**HARTZELL PROPELLER LLC**  
**ALERT SERVICE BULLETIN**  
**TRANSMITTAL SHEET**  
**HC-ASB-61-409**  
**A-1373 Self-Locking Hex Nut, 7/16-20**

This page transmits a revision to Alert Service Bulletin HC-ASB-61-409.

Revision 1 is issued to change the following in the Alert Service Bulletin:

Affected A-1373 Hex Nut Identification

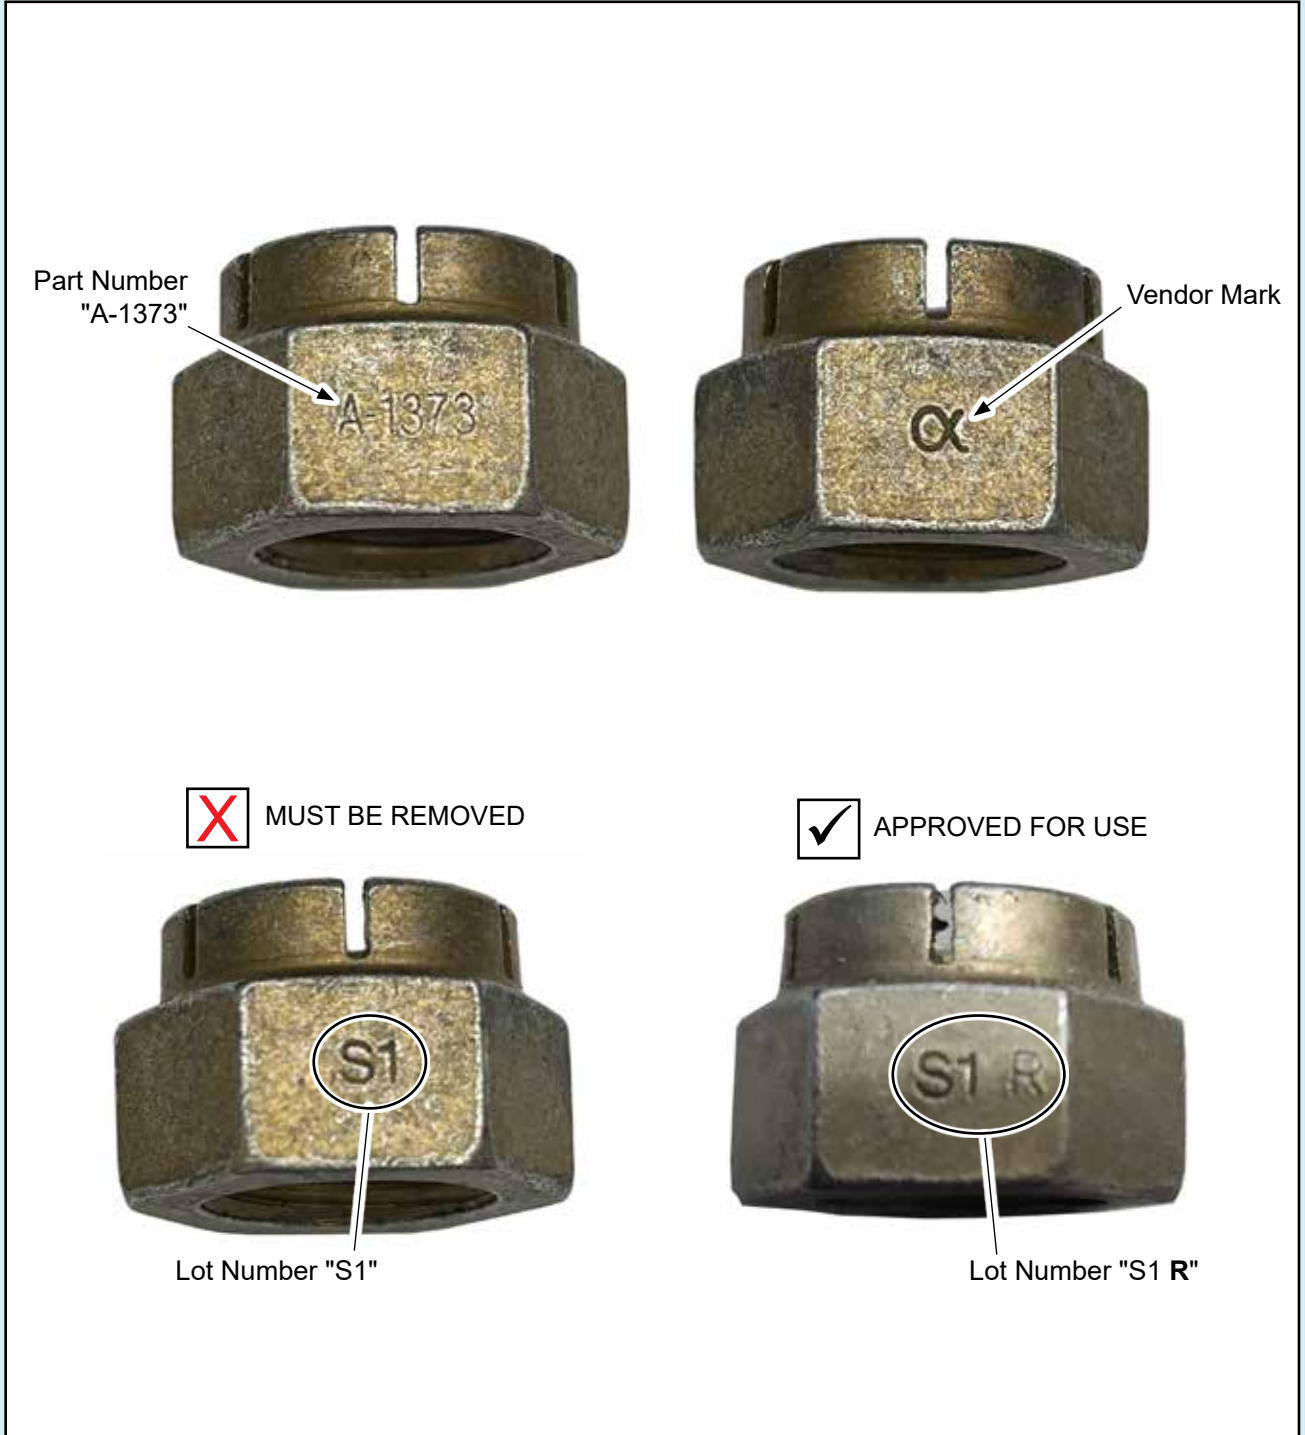
- Revise Figure 1, "Affected A-1373 Hex Nut Identification"
- Revise the section, "Inventory Inspection"
- Revised the section, "Blade Clamp Nut Inspection"

**NOTE:** A-1373 hex nuts marked with lot number "S1 R" as shown in Figure 1, are approved for use. These nuts can be returned to inventory/stock.

- (a) A-1373 hex nuts marked with lot number "S1" as shown in Figure 1 must be removed from inventory and returned to Hartzell.
- (b) Complete and sign the Parts Order/Compliance Form in the Appendix section of this Alert Service Bulletin.
  - 1 Send the completed form to Hartzell Propeller to initiate the order for the required parts.

**Blade Clamp/A-1373 Hex Nuts**  
**Figure 2**

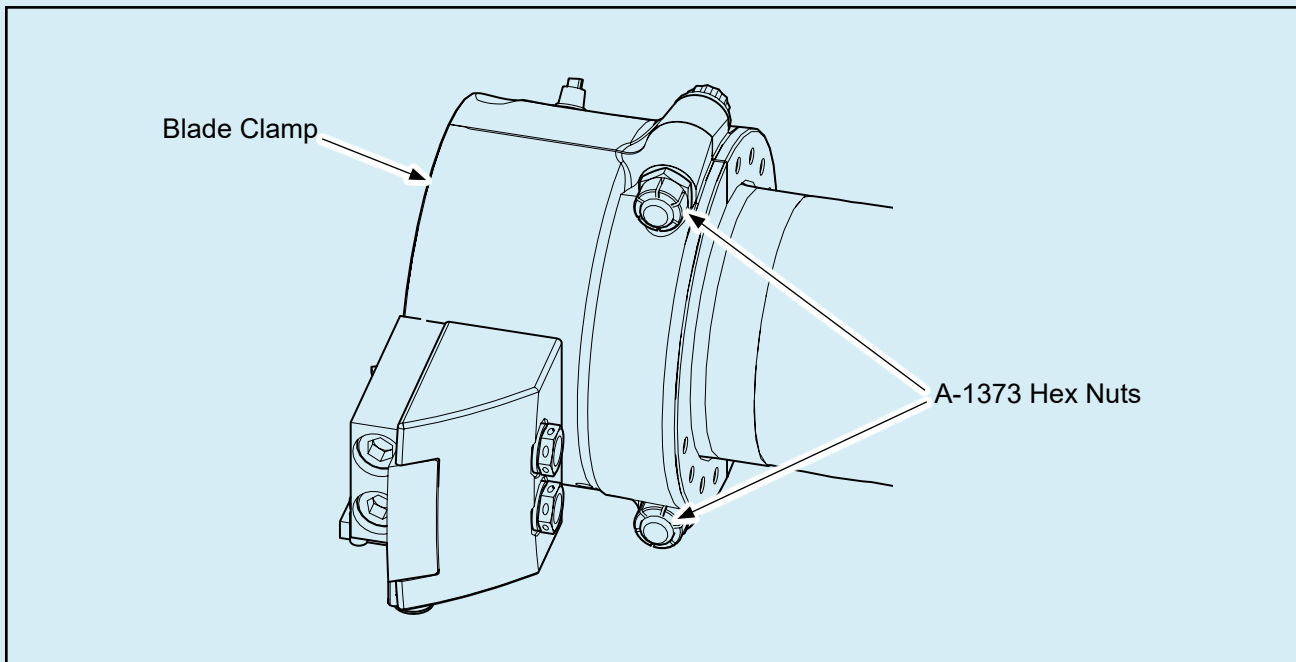
- (1) Remove the spinner dome in accordance with the applicable Hartzell Propeller owner's manual.
- (2) Examine the blade clamp nuts (Figure 2) to identify the lot number marked on each A-1373 hex nut (Figure 1).

- (a) A-1373 hex nuts marked with lot number "S1" must be replaced in accordance with the "Blade Clamp Nut Replacement" procedure in this section within 125 flight hours of this inspection.
- (b) A-1373 hex nuts marked with lot numbers other than "S1" are not affected by this Alert Service Bulletin and require no further action.
- (3) Make an entry in the propeller logbook indicating this inspection was performed in accordance with this Alert Service Bulletin.

- (3) Remove the affected A-1373 hex nuts from each blade clamp (refer to Figure 2) in accordance with the applicable Hartzell Propeller overhaul manual.
